# KARREEBOSCH WIND ENERGY FACILITY: VISUAL SPECIALIST COMMENT FOR THE PART 2 AMENDMENT, FINAL LAYOUT & EMPR APPROVAL PROCESS

Prepared for: WSP Group Africa (Pty) Ltd

Title	Karreebosch Wind Energy Facility: Visual Specialist Comment
Project Manager	Kerry Schwartz
Project Manager Email	klschwartz@slrconsulting.com
Author	Kerry Schwartz
Reviewer	Liandra Scott-Shaw
Keywords	
Status	Draft
Report No.	1
SLR Company	SLR Consulting (South Africa) (Pty) Ltd

Figure 2: Proposed Final layout of the Karreebosch WEF and associated infrastructure (source: G7, 2022).

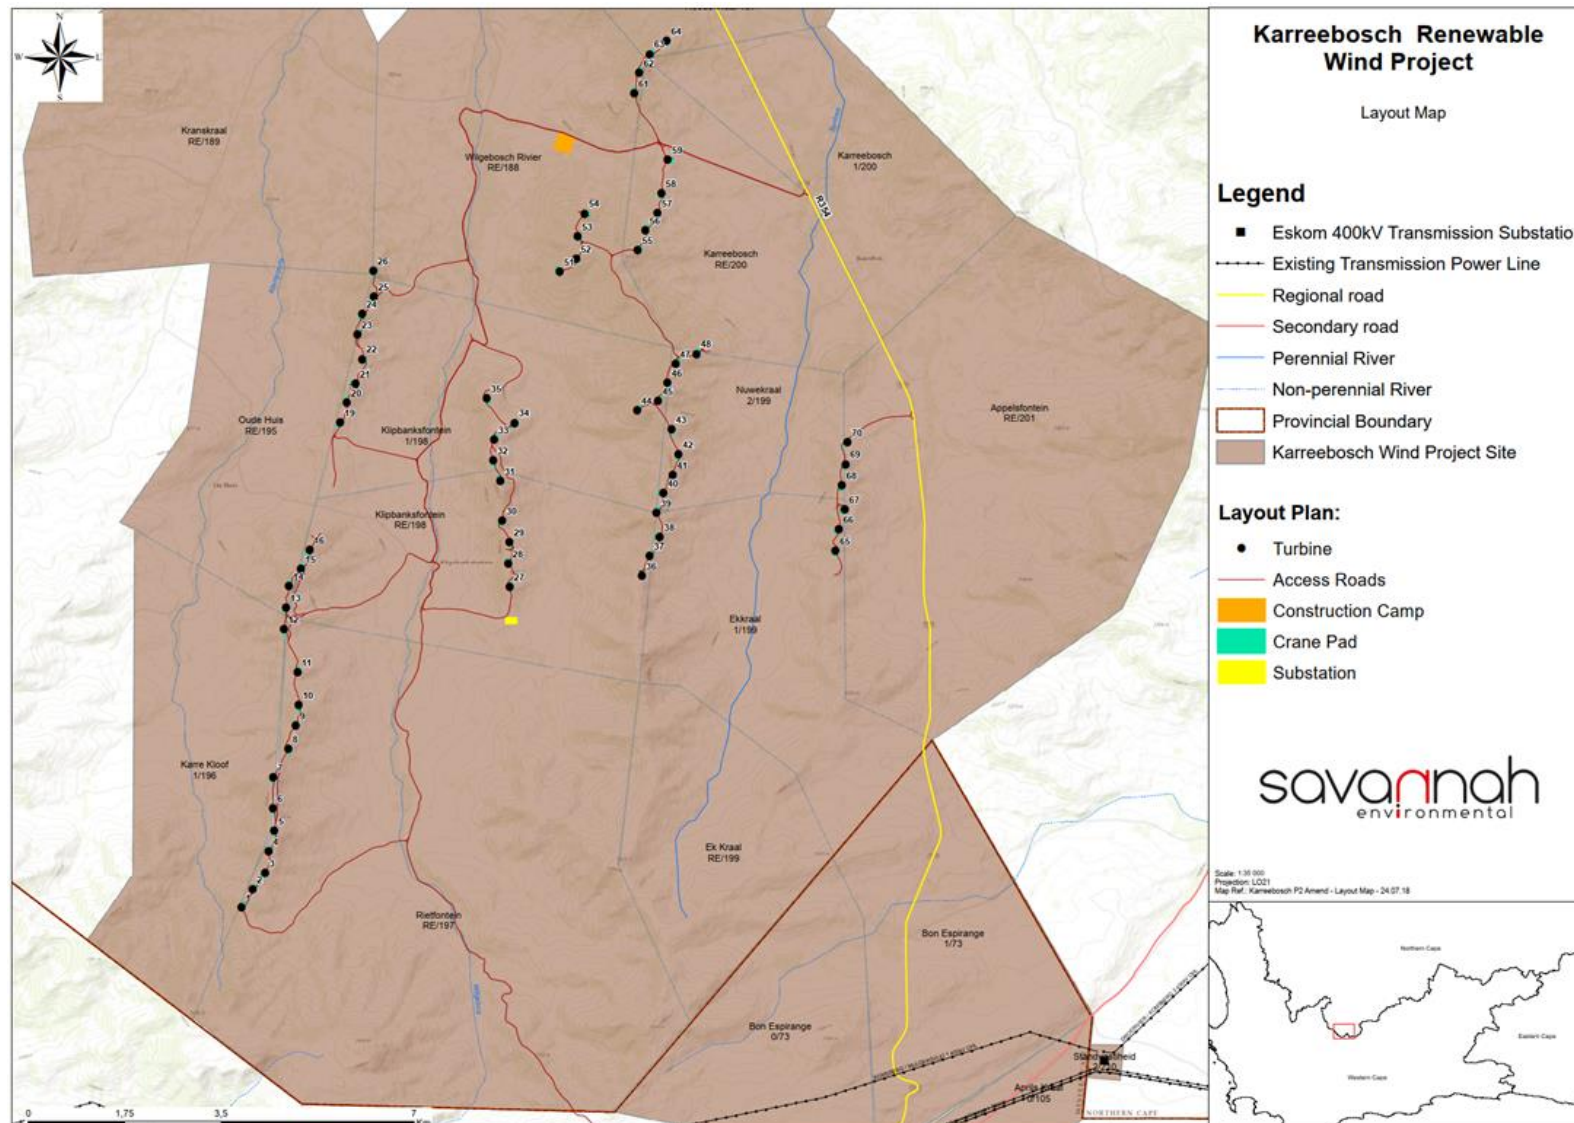
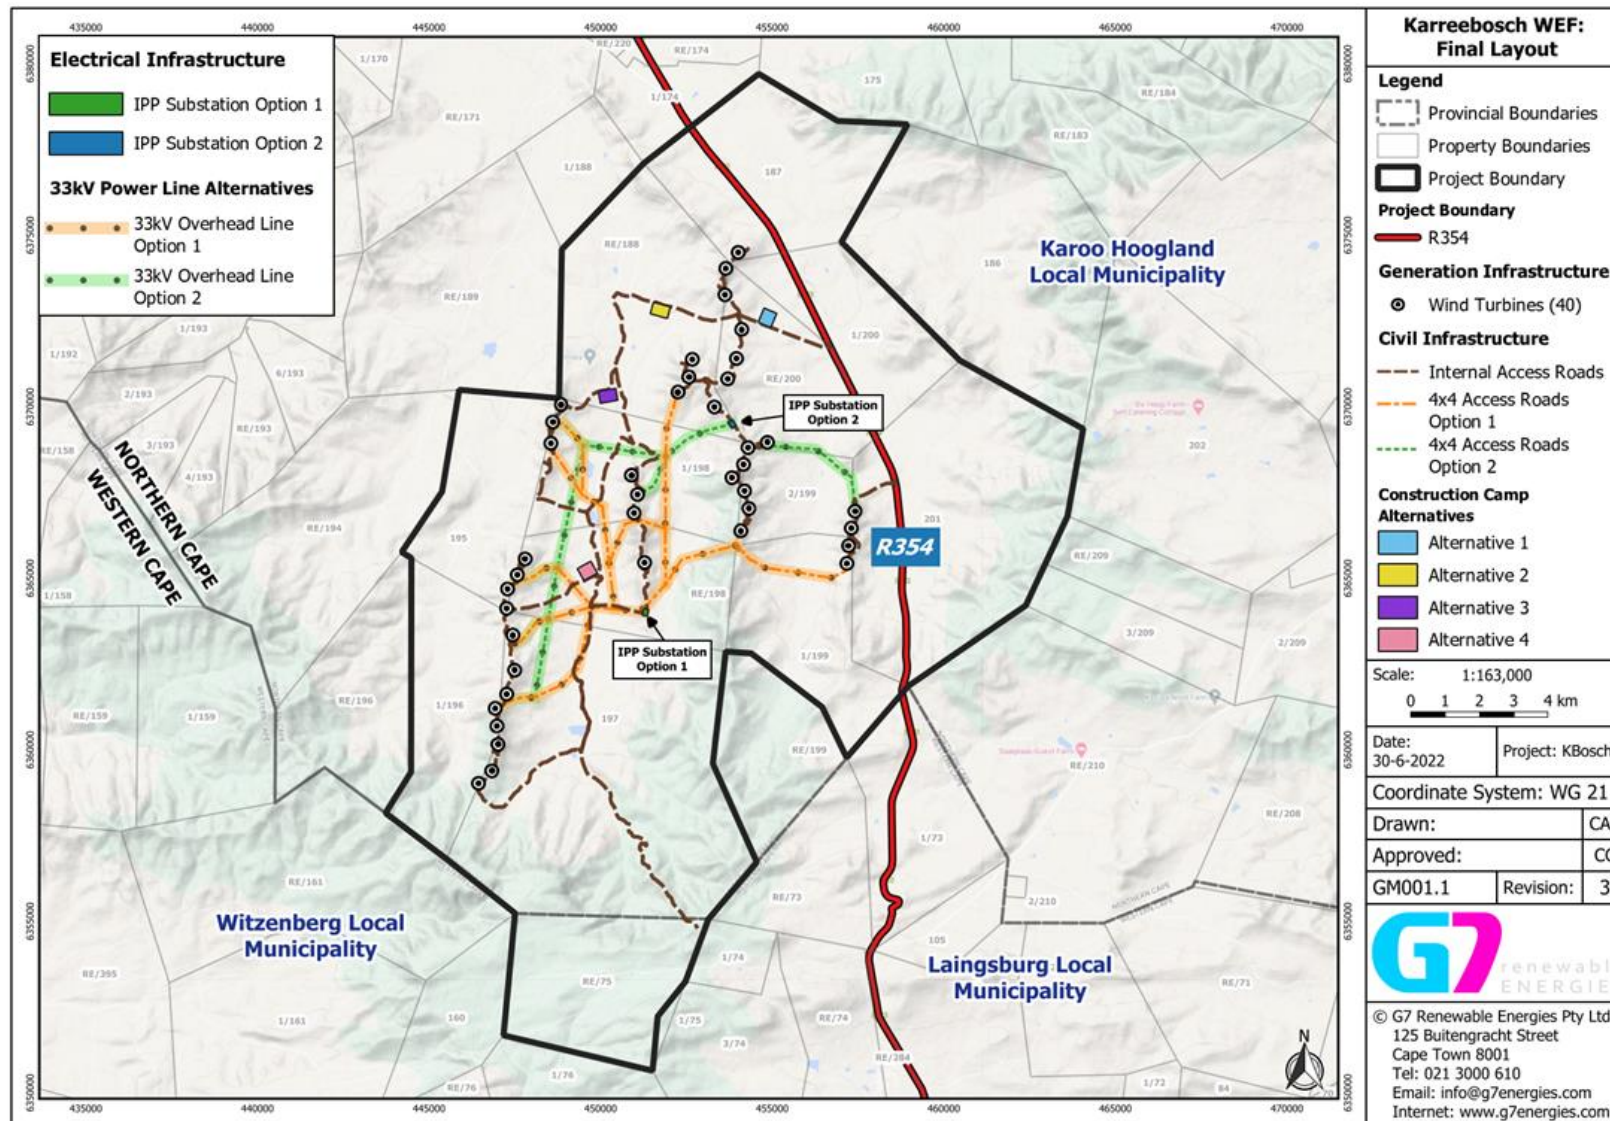
In addition, the change in the turbine specifications being proposed for the Karreebosch WEF has allowed for a reduction in the number of turbines required for the facility. Hence, a total of twenty-five (25) turbines have now been removed from the authorised layout depicted in **Figure 1**. This has in turn resulted in a slight reduction in the area from which the turbines will be visible (viewshed). In addition, with fewer turbines in evidence, there will be less visual clutter in the landscape and the cumulative impacts would be slightly reduced.

As part of this amendment application, Specialists are being asked to assess updated aspects of the layout as described in **Table 1** and as shown in **Figure 2**. From a visual perspective, the most significant changes in the layout are as follows:

- A reduction in the number of turbines, resulting in the removal of 25 turbines from the layout; and
- Minor adjustments to the positioning of the remaining 40 turbines;

The proposed updates in the WEF layout as outlined above do not deviate significantly the previous layouts that were fully assessed in the VIA undertaken in July 2015, with further visual comment being provided in July 2018. In addition, it has been established, via desktop assessment using Google Earth imagery, that, although the landscape to the south of Karreebosch WEF is undergoing significant change as a result of the development of the Roggeveld WEF (which has been operational since 2021), there has been little change since 2018 in the baseline characteristics and the number of sensitive receptors across the remainder of the study area. As such, it is not anticipated that the final layout will result in any changes in the significance of the impacts identified in the VIA, nor will it result in any additional visual impacts.

**Figure 3: Relative Landscape Sensitivity (July 2022)**

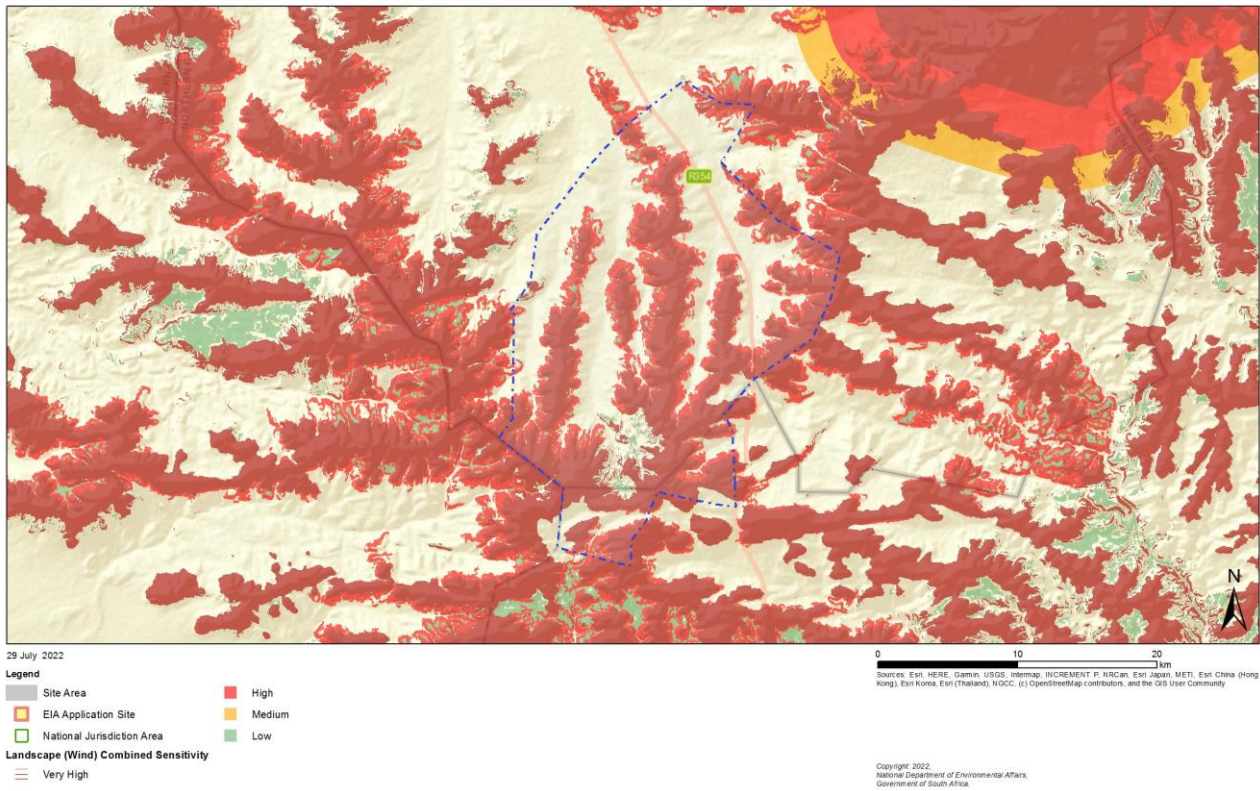
Under the Landscape Theme, as shown in **Figure 3** below, the tool identifies areas of Very High and High sensitivity in respect of WEF development within the Karreebosch WEF project area. According to the Screening Tool, the high sensitivity rating applied to the project area is associated with the presence of natural features such as mountain tops, high ridges and steep slopes. Based on these criteria, a significant portion of the site would be ruled out for WEF development.

As most of the turbines are located on these ridges, they will theoretically be visible from a number of visual receptors. In general however, the development is positioned in such a way that, in many cases portions of the turbines will be screened from view by topographic features. In addition, viewing distance must be considered when assessing visual impacts, as beyond a certain distance, even large developments tend to be much less visible, and difficult to differentiate from the surrounding landscape. The visibility of the proposed development from the identified receptors was examined in detail in the original VIA for the Karreebosch WEF. Highest levels of visual impacts will be experienced by receptors within 5km of the nearest wind turbine, although in this instance impacts would be reduced by the fact that these receptors are in fact homesteads located within the project area for Karreebosch WEF. Turbines are also expected to be at least partially visible from sections of the R354 which is a recognised tourism route, although the level of impact would depend on the level of screening provided by the topography, and the distance of the viewer from the nearest turbine. It has been noted that the proposed WEF layout recognises a 1km buffer along the R354 which will, to some degree, reduce the level of impact on travellers using this route.
